Model AS7PROG Autostart 710/720 Programmer

mi5611
revision A, 6th June 2002
catalogue section 75

Application Notes

Changes to Programmer Specification

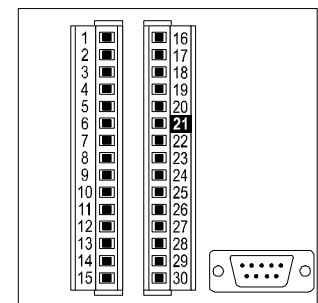
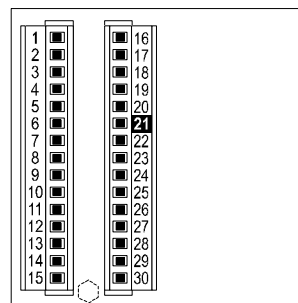
The design of the programmer after June 1998 is slightly different to units manufactured before this date. All units feature the keypad, flying lead and 15 way terminal block, but units built after June 1998 are also fitted with a 9 way D-type connector:-

Old (before June 1998)

New (after June 1998)

The new specification of programmer is designed to work with the latest versions (V1.0 or higher) of the AS710S and AS720S, also released in June 1998.

Updating an old specification programmer

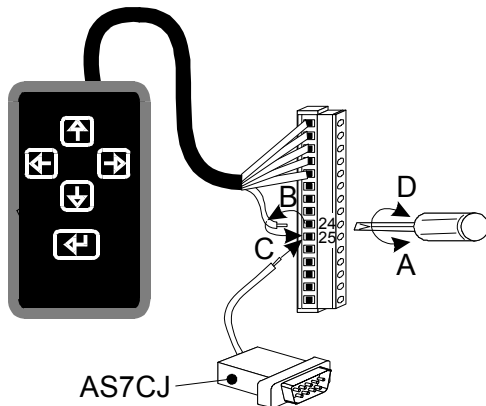
On older Autostarts, pin 24 (the alarm output) gives a negative DC signal when the Autostart is in program mode. This negative signal is used as a common feed for the push-button switches in the keypad unit. When each button is pushed, the negative DC signal is fed back into the appropriate Autostart input (pins 16 to 20), causing the Autostart to be re-programmed.

On the latest specification Autostarts, pin 24 does not give a negative DC signal. The required signal is therefore derived from the Autostart's communication port, through the new D-connector. This negative signal is also now routed on to pin 25 of the connector, rather than on pin 24. (The reason is that pin 24 can in certain circumstances give a positive output, and a subsequent connection to negative DC would result in an internal short circuit.)

Old specification units may be updated by ordering Murphy model AS7CJ (stock code 76.70.0119), which comprises the new D-connector and flying lead.

The extra components are added as follows:-

- On the programmer unit connection block, loosen screw terminals 24 (containing the single white wire) and 25.
- Remove the white wire from pin 24.
- Re-insert the white wire into pin 25, along with the single wire from the D-connector (AS7CJ).
- Retighten terminals 25 and 24.

Alternatively, a flying lead (without the D-connector) may be wired into programmer pin 25 as above.

When programming the Autostart, the other end of the new flying lead must be connected to negative DC, e.g. on pin 1 of the Autostart's other terminal block.

WARNING: an incorrect connection to pin 25 (e.g. to positive DC) will cause damage to the Autostart.
